Hawke's Bay Airspace Review – Airways Submission Background

HBECAC submission

Airways responses to HBECAC submission suggestions

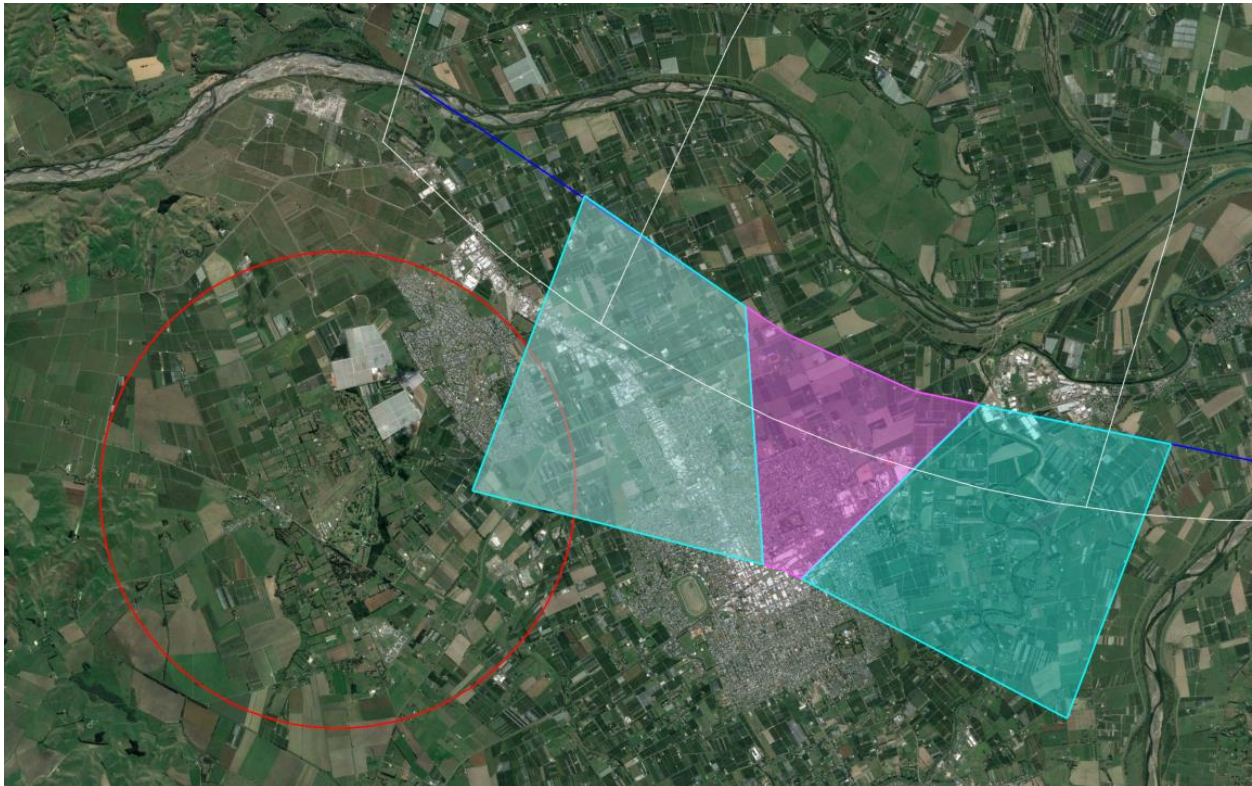
- *The removal of the VOR/DME Arc for 34, or a note on the Approach plate to the effect that parts of the approach are not fully contained within controlled airspace. (As has been done in Hamilton with the approaches from TAYLA and BUDEN).*

- *Removal of the VOR Cat C Base Turn Approach, or a note to the effect on the Approach plate that this approach is not contained within controlled airspace.*

- *RNAV and VOR departures out of Napier to the south routing via NOSAM, rather than via SOBET (which goes directly overhead Hastings) and SHAKA. At present the standard route clearances to Wellington and Christchurch out of Napier go via NOSAM. This tracking keeps all IFR traffic departing to the south out of Napier well laterally spaced from Hastings Aerodrome. Should revised RNAV tracking to the south of Napier still be required the lateral spacing away from Hastings Aerodrome and preservation of airspace over Hastings Aerodrome for departures to the south could still be maintained by shifting SHAKA to the west, and SOBET to the east.*

- *SHAKA to the west: shift SHAKA to the western side of the Ngaruroro River. To keep the climb gradient inside controlled airspace the CTR would have to be extended to the south west in this small area, or the 2000ft TMA start on the northern / north western side of the Ngaruroro River.*

- *SOBET to the east: shift SOBET east to a line going overhead Longlands, so that the climb gradient that required the 2000ft section of airspace was contained in the 1500ft CTA*

Airways Suggested Alternative

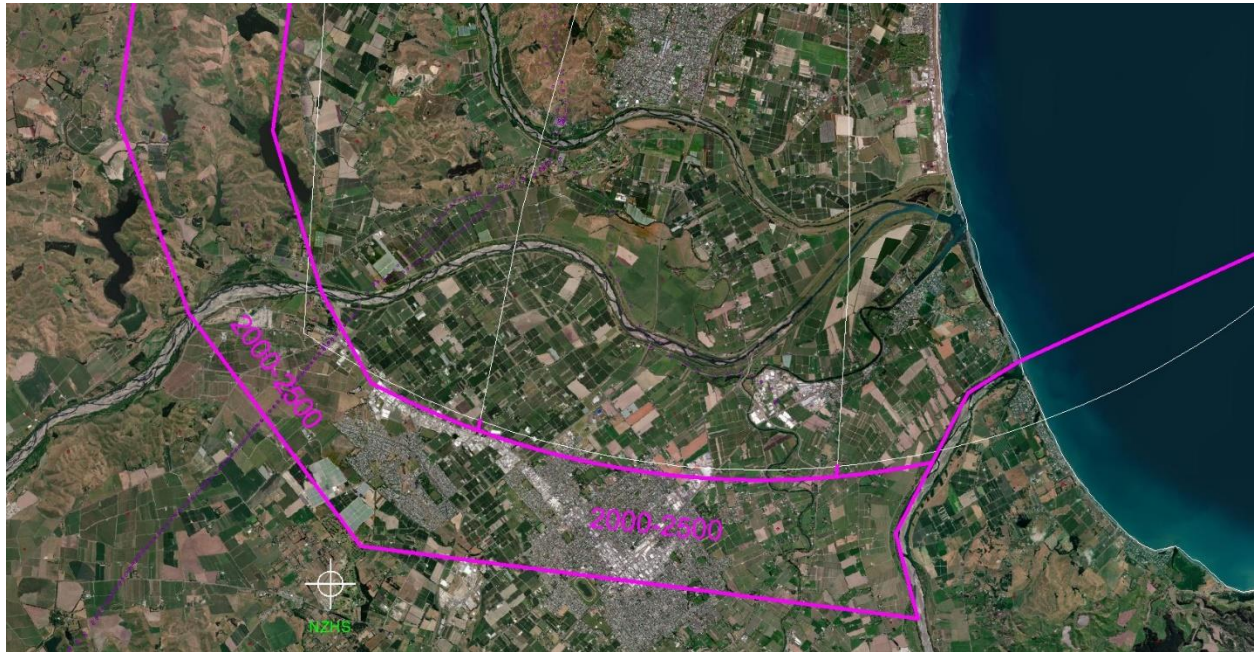
It was quickly determined that the HBECAC request for all airspace within a 2NM radius of NZHS to remain with a lower limit of 2500 ft would not be possible – the image below shows airspace volumes with 2000 ft lower limit (blue) and an airspace volume with 1500 ft lower limit (magenta) required to contain the proposed RNP RWY34, with a 2NM radius circle in red around NZHS.

Following these investigations, Airways suggest the following as a compromise that may address some of the HBECAC concerns while still providing adequate protection for IFR flights operating at Napier.

- **Retain the existing VOR/DME RWY34.** This IFP will not be fully contained but is already annotated as such. Note also that while containment will not be assured, as there is more airspace around the CTR/D, this approach will be *closer* to full containment than it is currently. This aligns with not just the current situation but also the current airspace containment requirements as per the Aeropath NOTOD so can already be deemed acceptable to CAA.

- **Design the new RNP RWY34 with a 3.1° descent gradient.** This is a less severe gradient than 3.2° and is more likely to be acceptable to operators, and there are many examples of 3.1° profiles across the country (including the new RNP RWY16 at NZNR).

- **Re-draw the airspace to the south of NZNR to accommodate these design changes.** This will require:
 - **Expanding the southern CTR/D boundary by 0.12NM** and blending this with the other CTR/D proposed boundaries in the Airways submission.

- **Creating the new CTA/D boundaries with lower limit of 2000 ft to the south of NZNR.**
 - **Removing the CTA/D boundaries with lower limit 1500 ft to the south of NZNR.**

Suggested alternative airspace boundaries

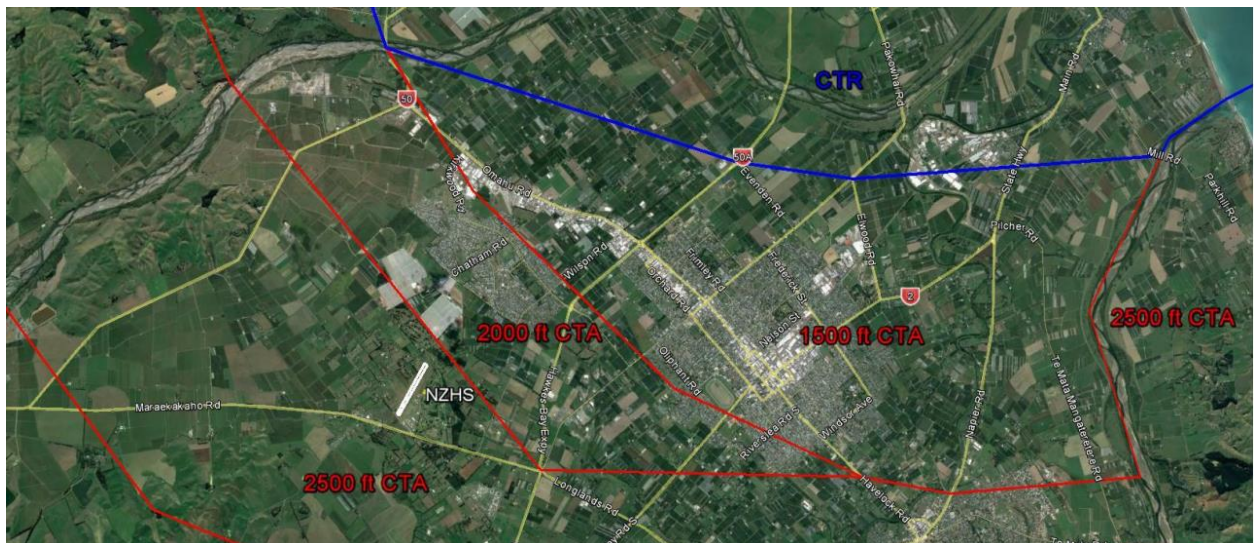
Should the suggestions on the previous page be adopted, the graphic above shows what the alternative airspace boundaries could look like. Current submission below for comparison.

- The magenta lines show the proposed new airspace, the thin white lines show the existing airspace/instrument sector (and see graphic below for current Airways submission).
- The CTR/D boundary is pushed further south than the Airways submission, slightly further than the existing CTR boundary. This is then blended on the eastern and western sides to join the other airspace boundaries proposed.
- The airspace volume with lower limit 2000 ft starts in the east following a prominent geographic feature (Tukituki River), wraps around the southern CTR/D boundary to join the required airspace to the west, and is significantly smaller than previously proposed (note the racecourse sits just outside this airspace volume – in the current submission below it sits centrally).
- **No airspace with 1500 ft lower limit to the south of the CTR/D is necessary in this scenario.**

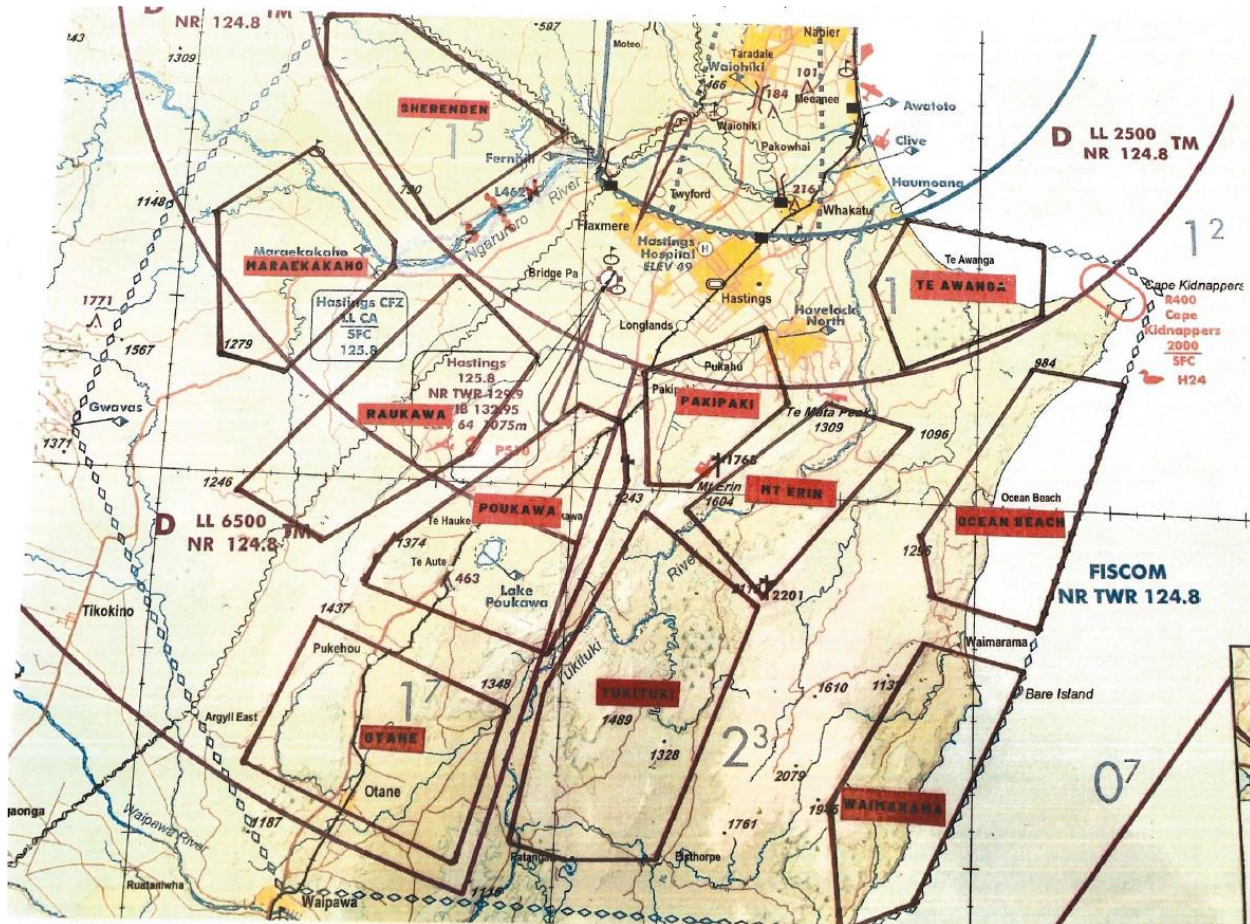
- *The removal of the VOR/DME Arc for 34, or a note on the Approach plate to the effect that parts of the approach are not fully contained within controlled airspace. (As has been done in Hamilton with the approaches from TAYLA and BUDEN).*
- *Removal of the VOR Cat C Base Turn Approach, or a note to the effect on the Approach plate that this approach is not contained within controlled airspace.*

The above two suggestions are incorporated into this review document and formed the basis for the review and eventual Airways suggested alternative.

REVISION – Additional airspace change to accommodate HBECAC training area

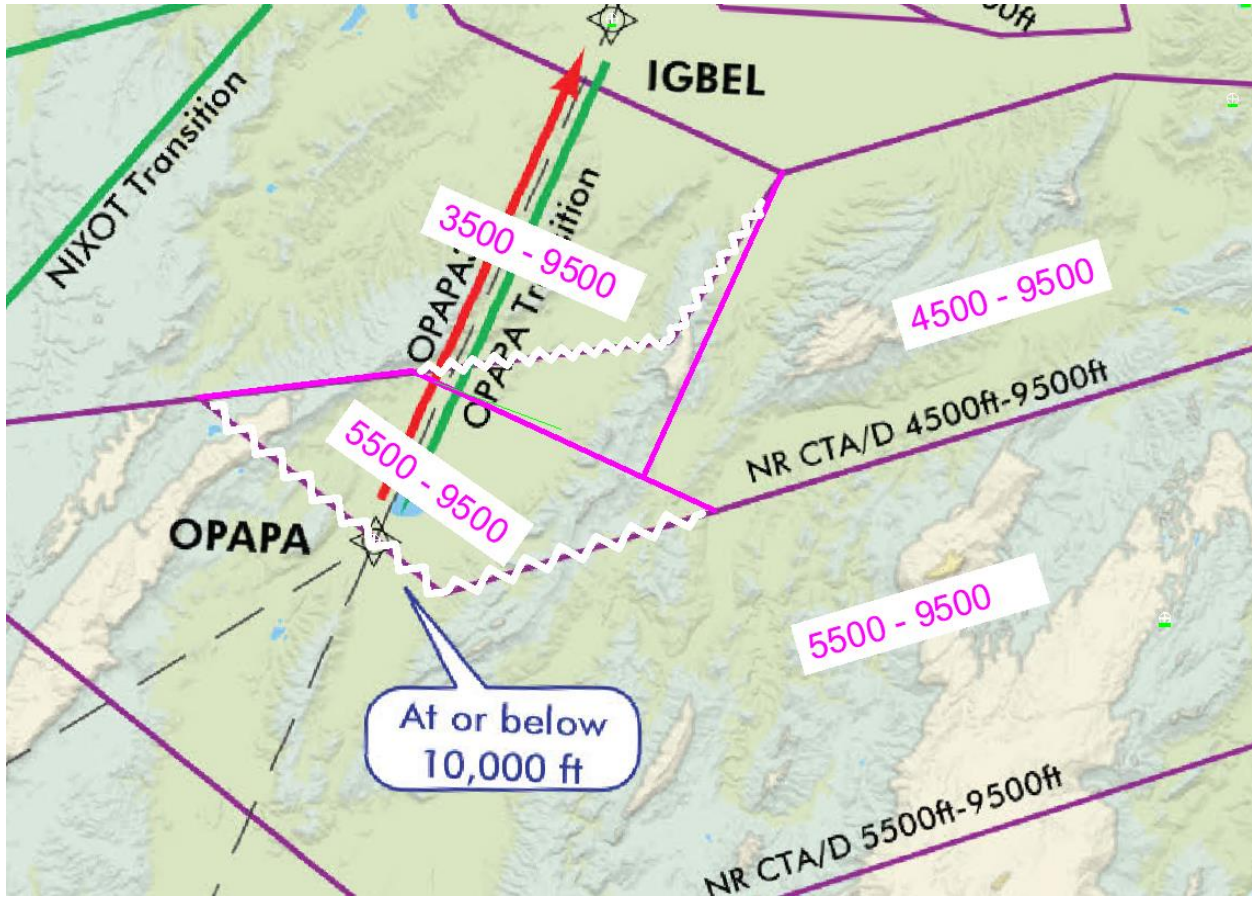
Following initial consultation with HBECAC to present the above proposal, a second area of the Airways submission that was requested to be reconsidered was the area overhead Lake Poukawa VRP, to the southwest of Hastings. The reason for this is the VFR training areas that HBECAC operate outside controlled airspace (see graphic below, with the Poukawa area in the centre).

Airways reviewed the airspace and were able to propose the following small amendments, which HBECAC consider to be an improvement as the airspace overhead the Poukawa training area will have less controlled airspace and only two levels (3500 ft and 5500 ft) rather than the three levels proposed in Airways' original submission (3500 ft, 4500 ft and 5500 ft).

- A small expansion of the 3500 ft CTA/D is necessary, so as to have minimal impact on the required climb gradients for IFR departures off runway 16 at NZNR
- The 5500 ft CTA/D is expanded overhead Lake Poukawa
- The 4500 ft CTA/D is truncated – some becomes 3500 ft, the majority 5500 ft CTA/D

Overall this constitutes a slight reduction in controlled airspace, and the only impact to IFR flights will be a small increase in the required climb gradient for airspace containment on some of the RW16 SIDs at NZNR – expected to be in the region of 5.4% until 6000 ft.
